ADDENDUM NO. 07

October 16, 2023

Northwestern School Corporation – Multiple Projects
3431 County Rd N 400 W
Kokomo, IN 46901

B. Drawing Number 2-CD101

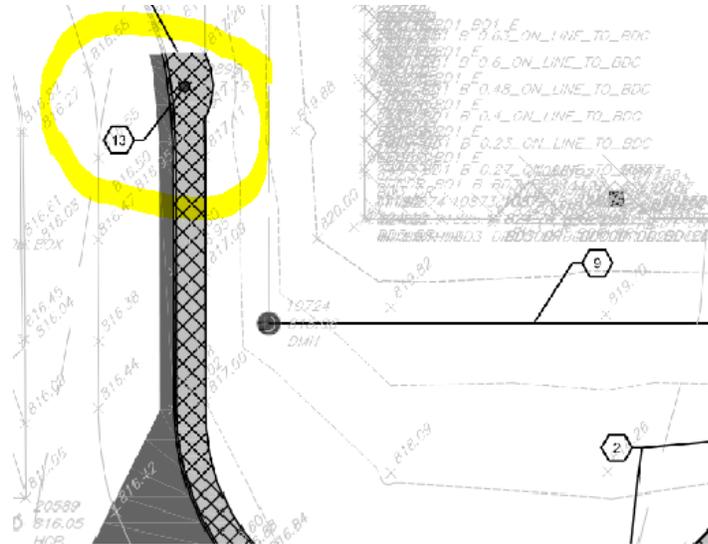
1. DELETE AND REPLACE Sketch as follows:

2. "Add note 13 " REMOVE AND RELOCATE EXISTING LIGHTPOLE IN ITS ENTIRETY, SEE ELECTRICAL DRAWINGS FOR DETAILS"

D. Drawing Number 2-C5101

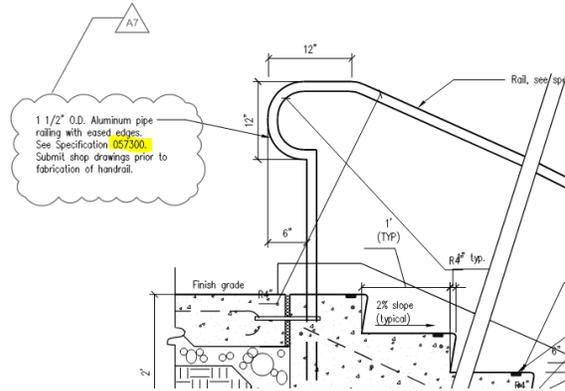
1. DELETE AND REPLACE Note as follows:

2. Change Note on detail 2B to say "See Specification 057300"

A. Drawing Number 2-A-210, 2-A-211

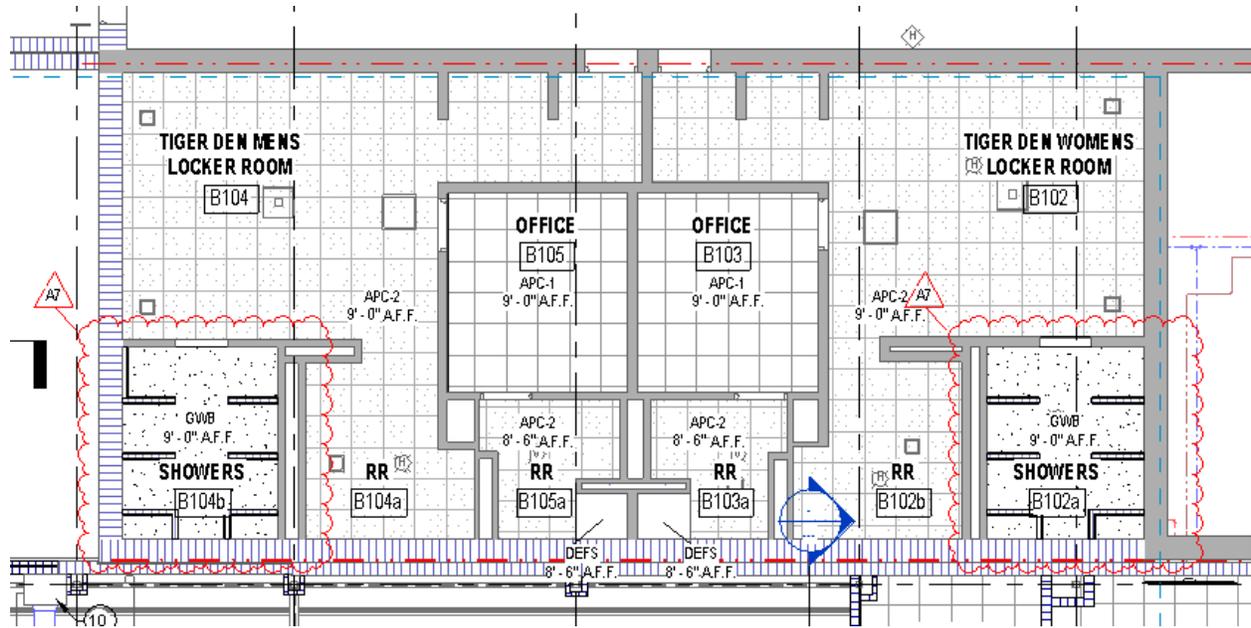
1. DELETE AND REPLACE Note 10 as follows:
"07 42 93 – (MSP) METALWORKS LINEAR - CLASSIC"

A. Drawing Number 2-I-206

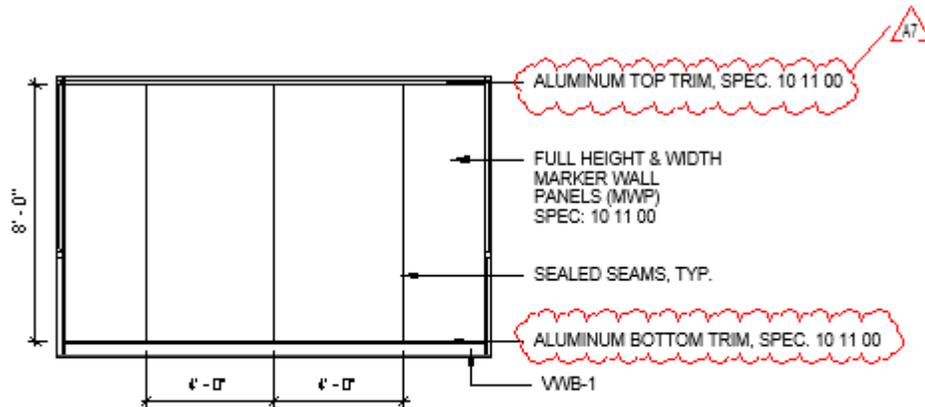
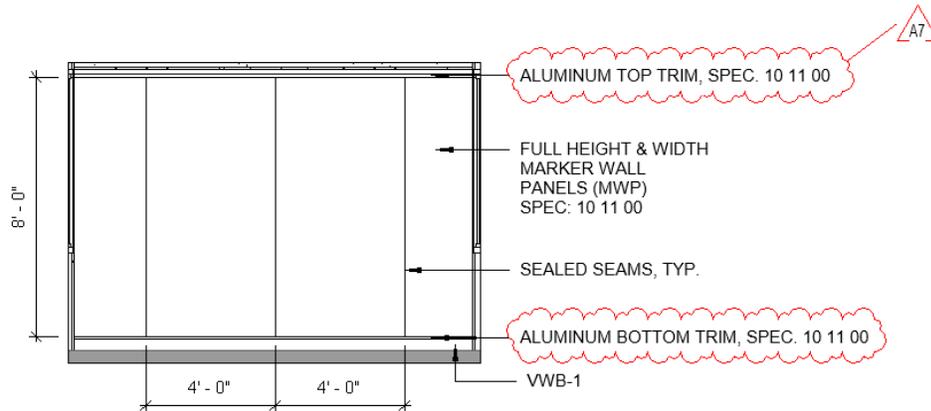
1. MODIFY Elevation(s) 5E & 5D as follows:

C. Drawing Numbers 2-MD1H1 and 2-MH1H1

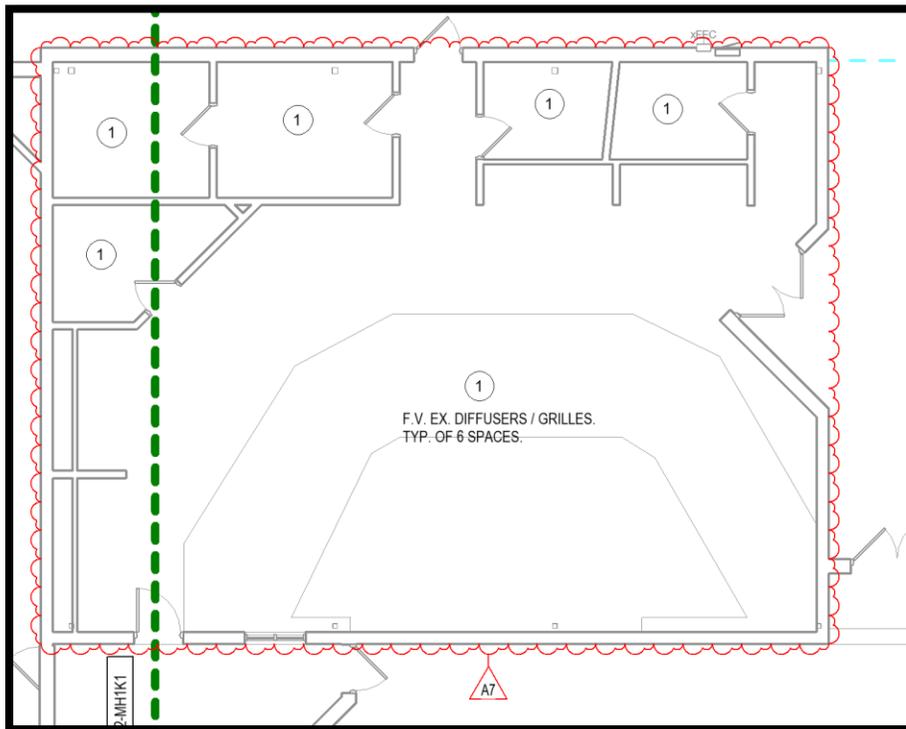
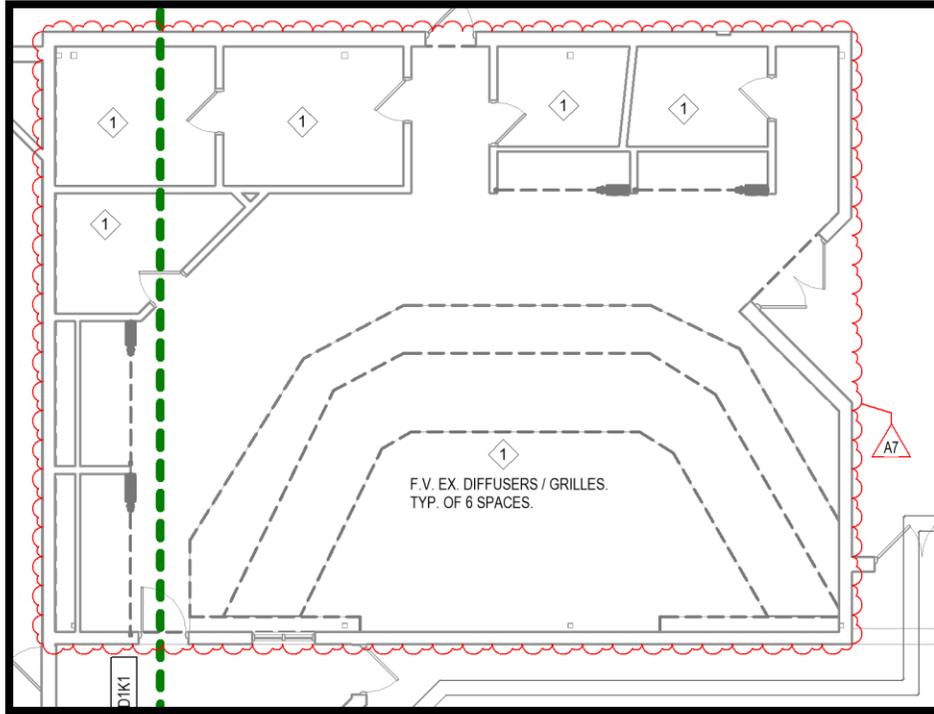
1. MODIFY Drawing as follows to field verify existing diffusers and remove/protect/replace to accommodate architectural ceiling replacement:

D. Drawing Numbers 2-MD1J1 and 2-MH1J1

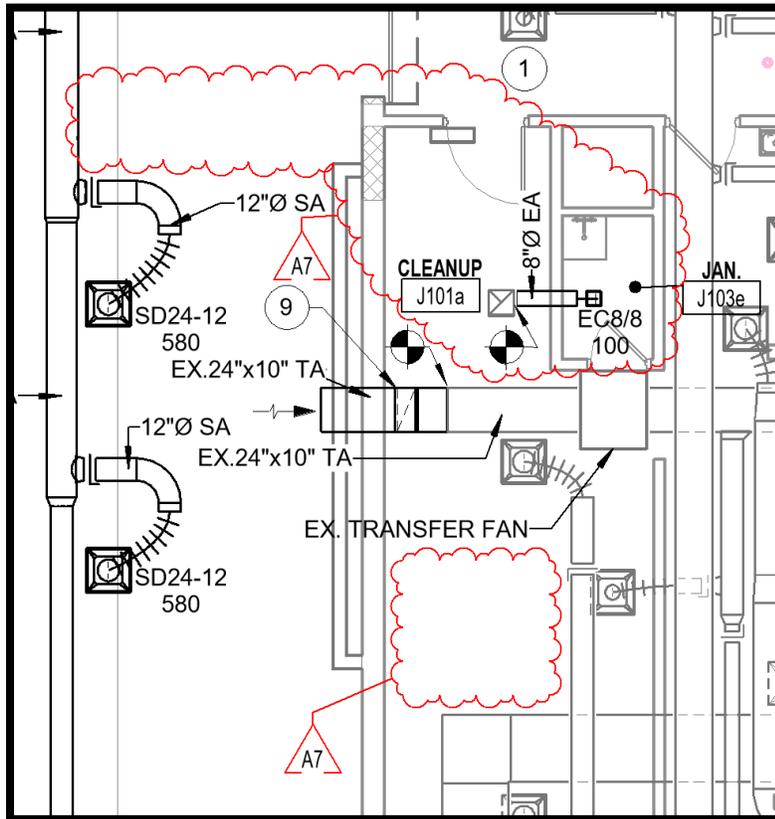
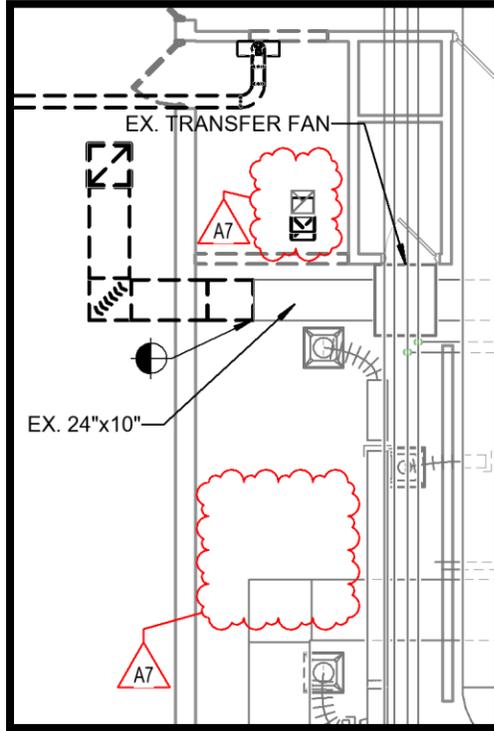
1. MODIFY Drawing as follows to accommodate architectural changes at janitor closet:

E. **Drawing Numbers 2-MD1K1 and 2-MH1K1**

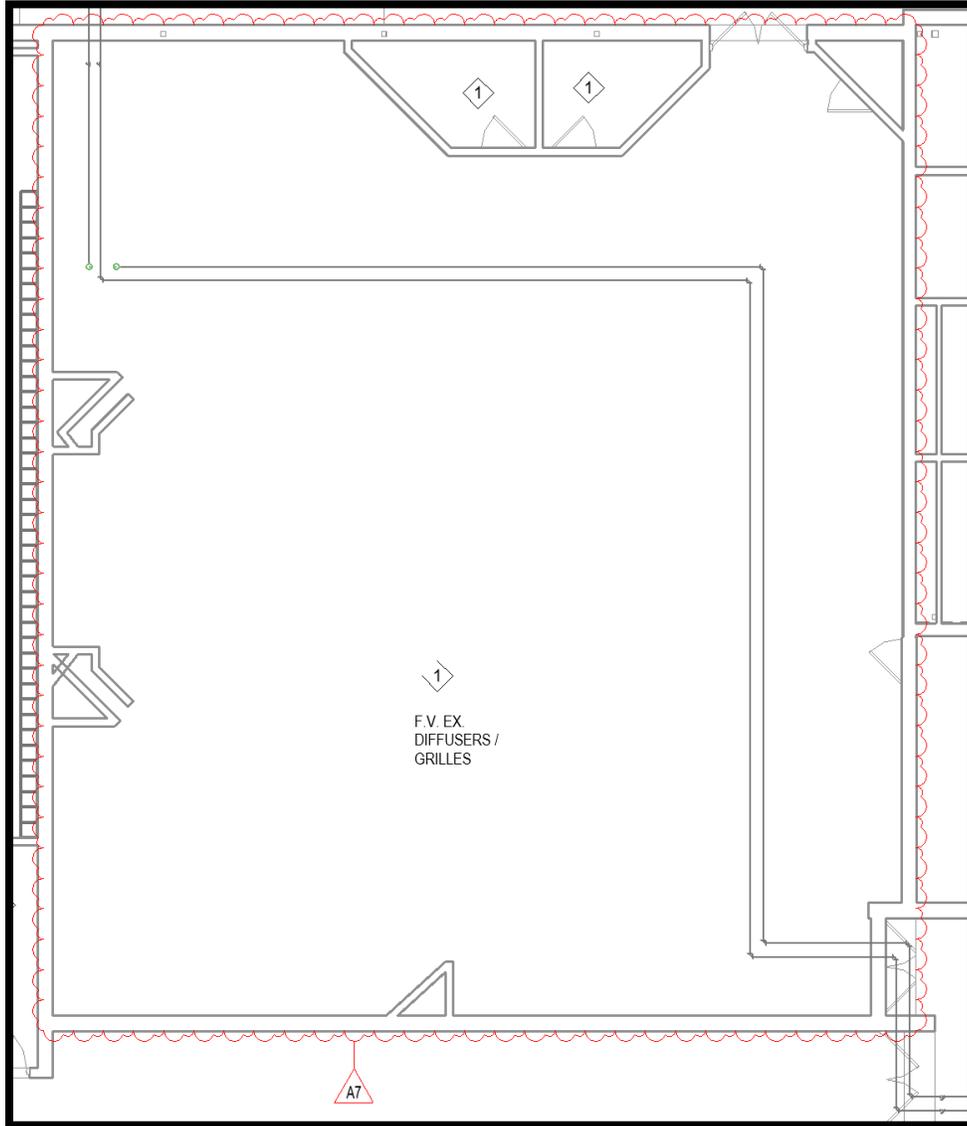
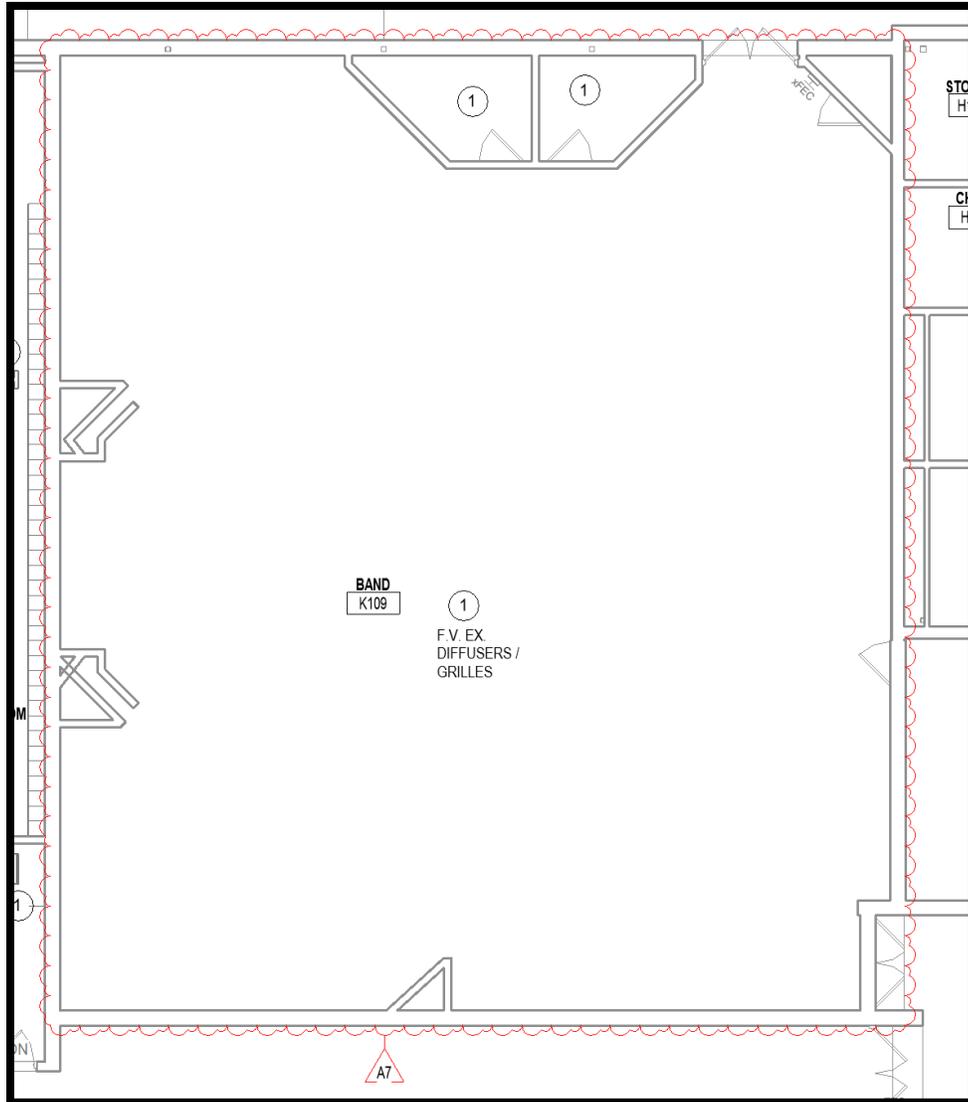
1. MODIFY Drawing as follows to field verify existing diffusers and remove/protect/replace to accommodate architectural ceiling replacement:

F. **Drawing Numbers 2-M-401, 2-M-402, 2-M-501, AND 2-M-502**

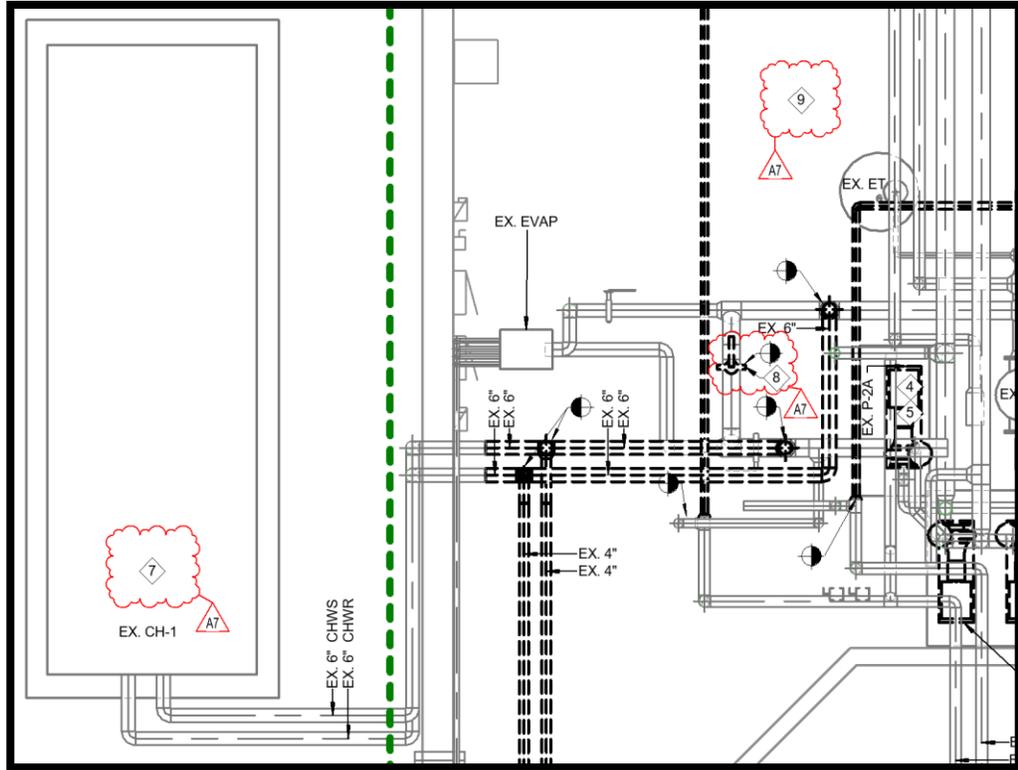
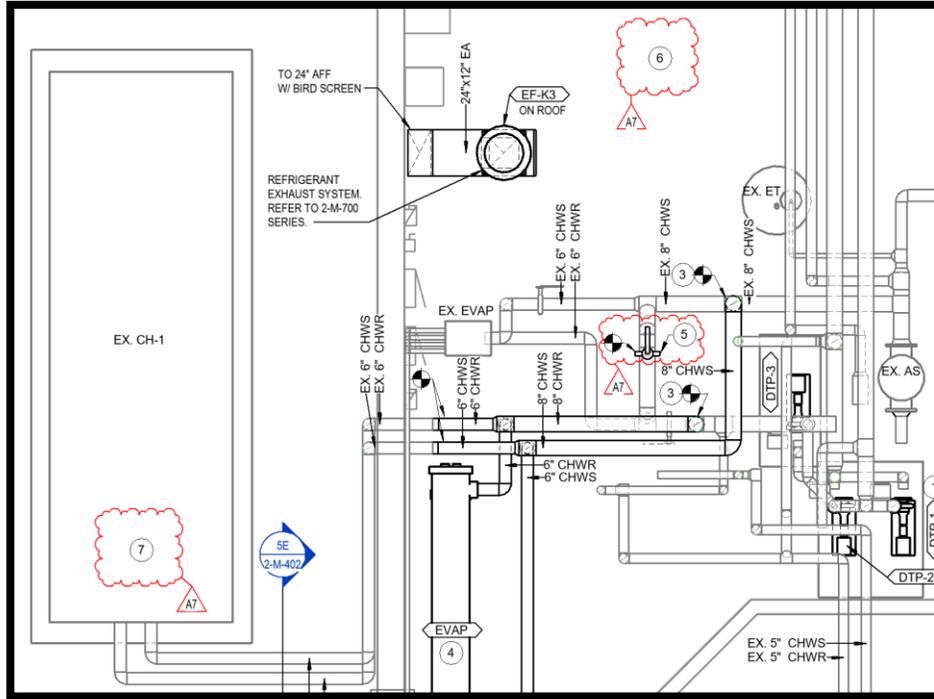
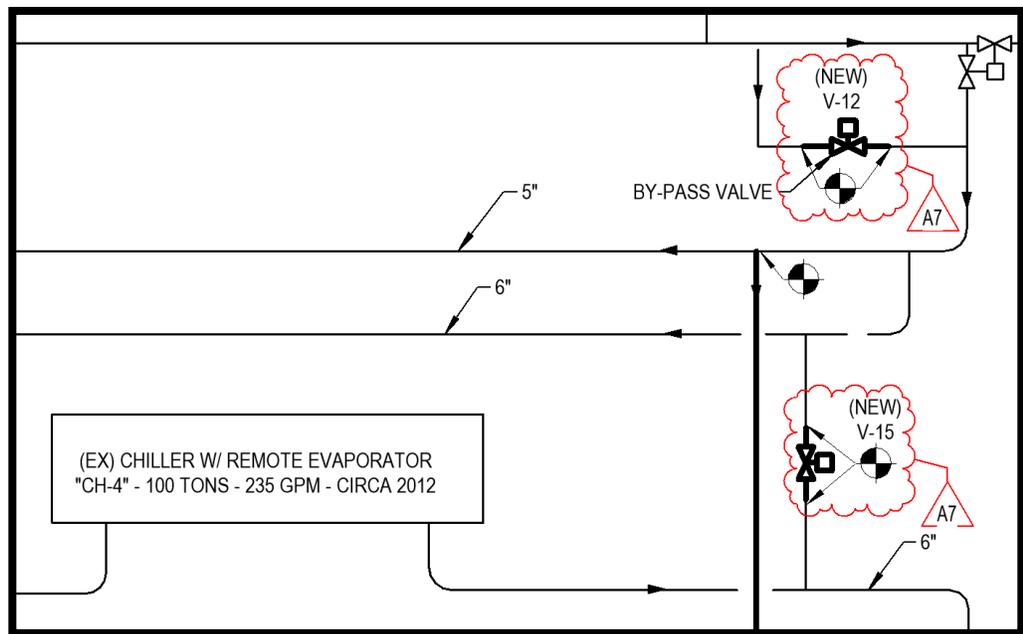
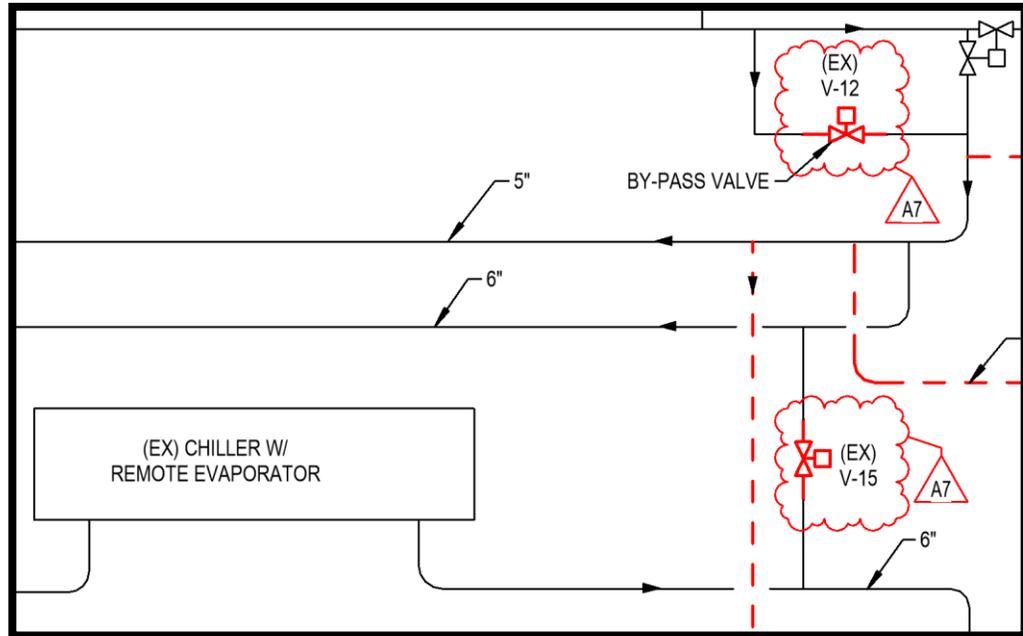
1. MODIFY Drawing as follows to add scope associated with replacing control valves V-12 and V-15:

I. **Drawing Number 1-M-701**

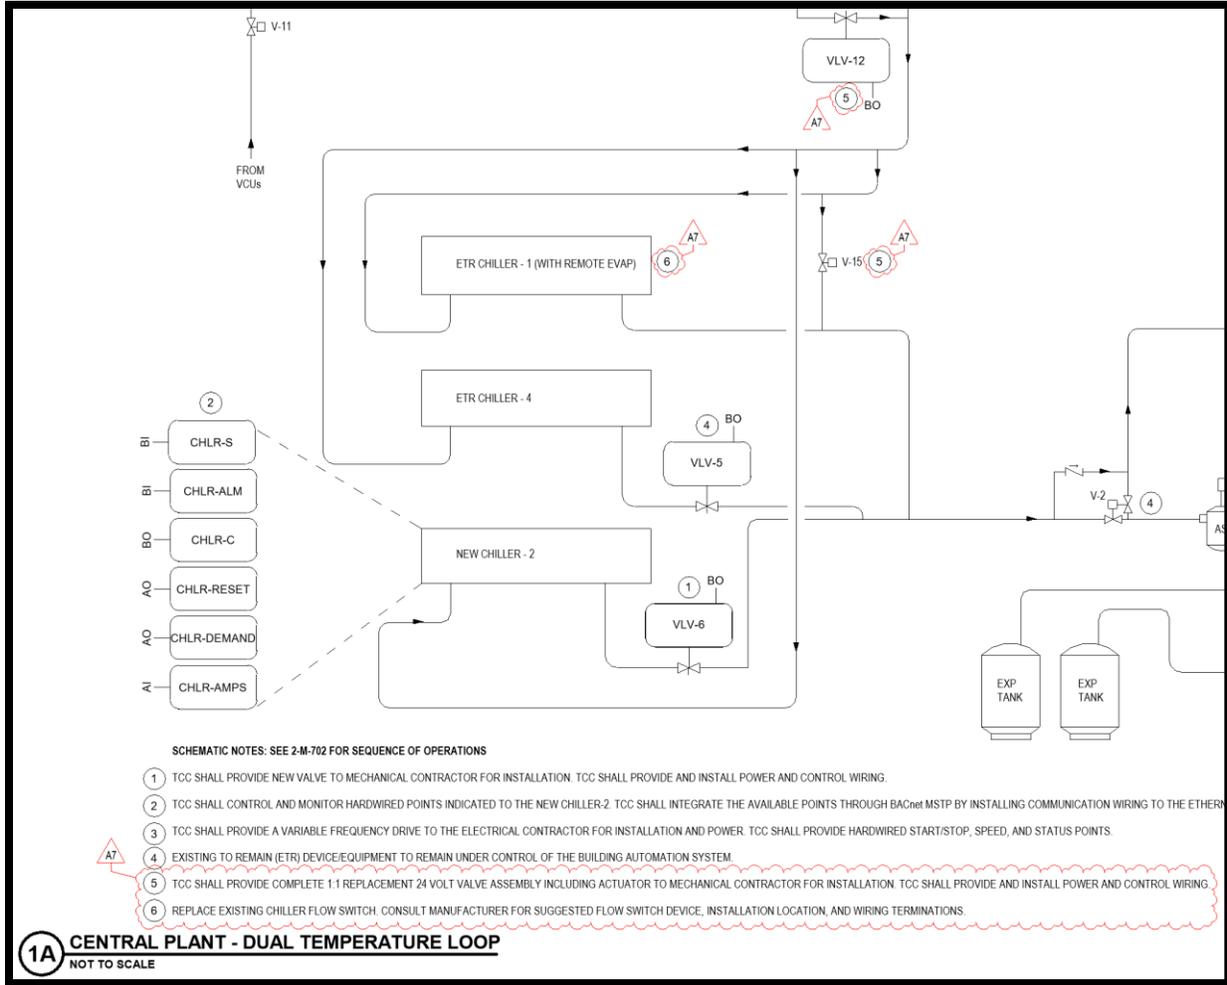
1. MODIFY Drawing Detail 1A as follows:

K. Drawing Number 2-M-703

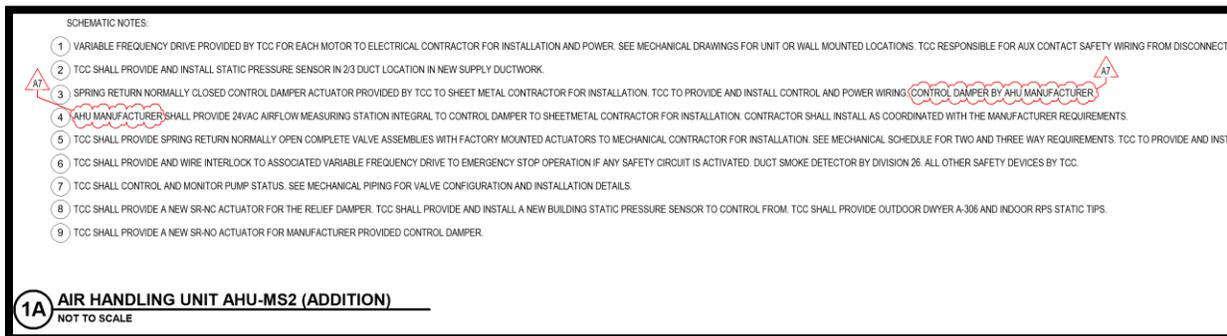
1. MODIFY Drawing Detail 1A as follows:

3. SHEET 1-ED1B1 – 1 – ELECTRICAL DEMOLITION PLAN – UNIT B

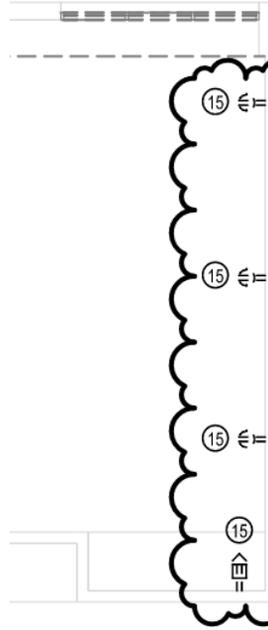
- a. Added more receptacles to be demolished in each classroom. See snip-it, typical of (9).
- b. Revised plan note #15 to say “Existing receptacle and wiremold to be removed. Existing circuit to remain above the ceiling for extension to new devices. Refer to new work on power and systems plans for additional information.”
